1971 Corvette: Service Bulletin: Anti-Diesel Relay

Subject: Anti-Diesel Relay

Bulletin No: 71-T-44

Date: Aug. 5, 1971

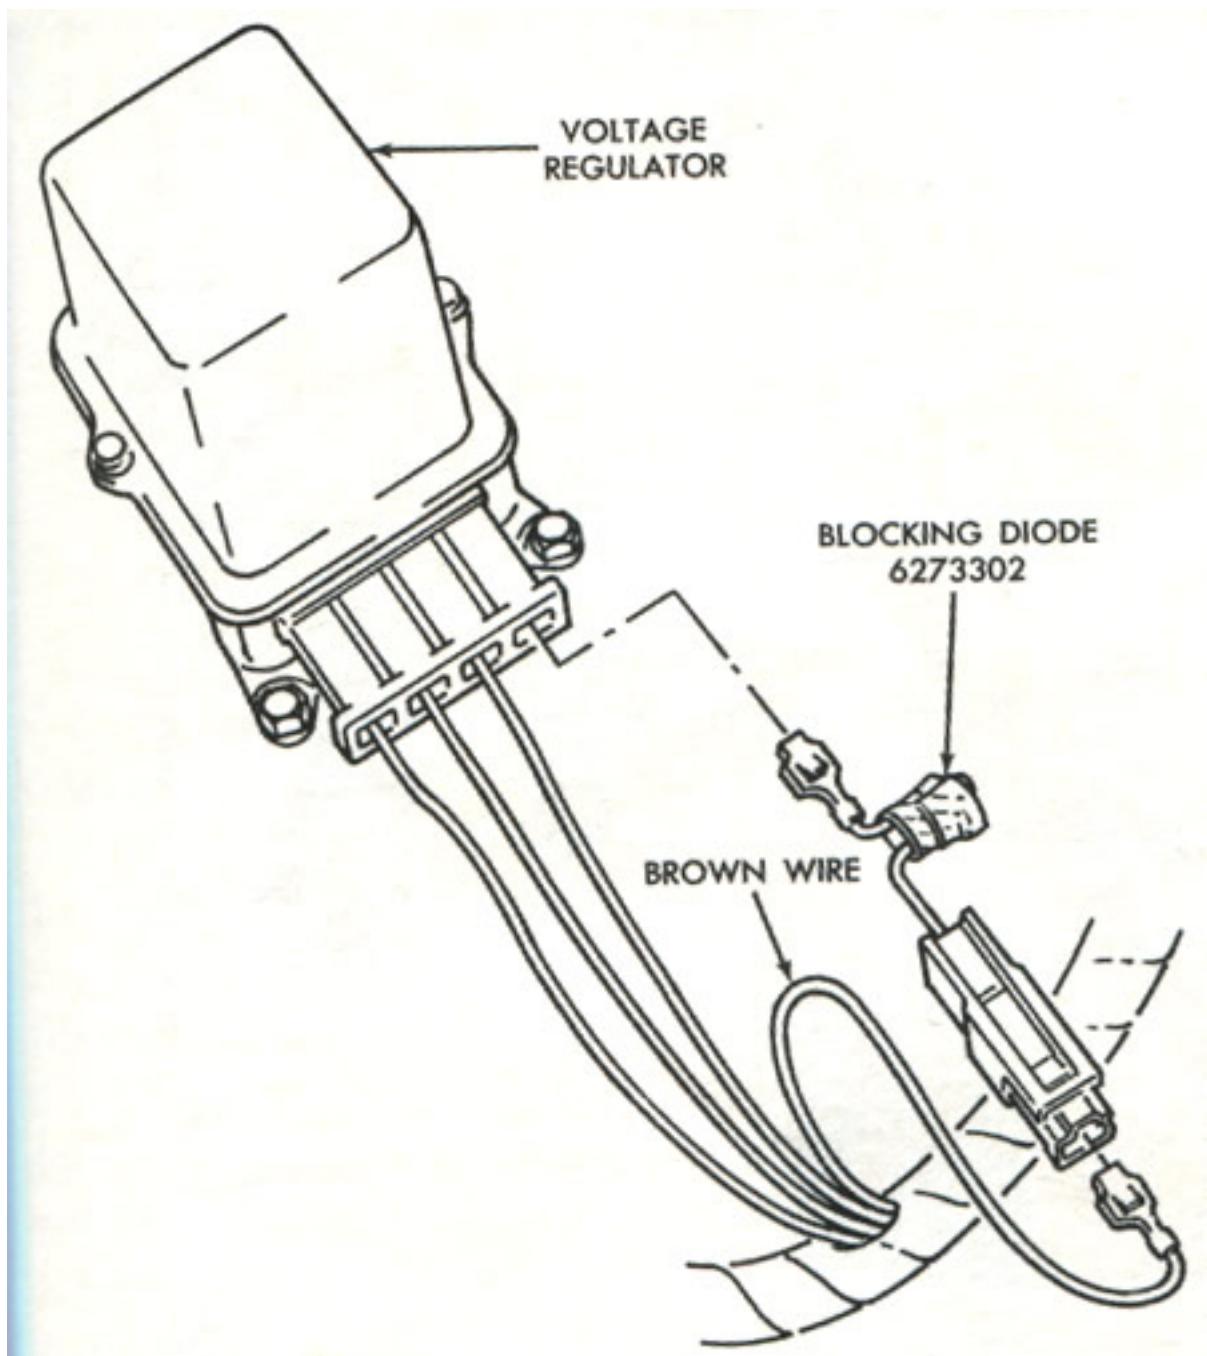
For service on light trucks, to prevent Delcotron feedback to the anti-diesel relay, blocking diode, Part Number 6273302, should be installed at the voltage regulator as outlined under Service Procedure - Truck.

1. Disconnect wiring harness from voltage regulator.
2. Remove brown wire from the plastic connector.
3. Install the blocking diode between the voltage regulator connector and the brown wire as illustrated in Figure 1.
4. Connect harness to voltage regulator.
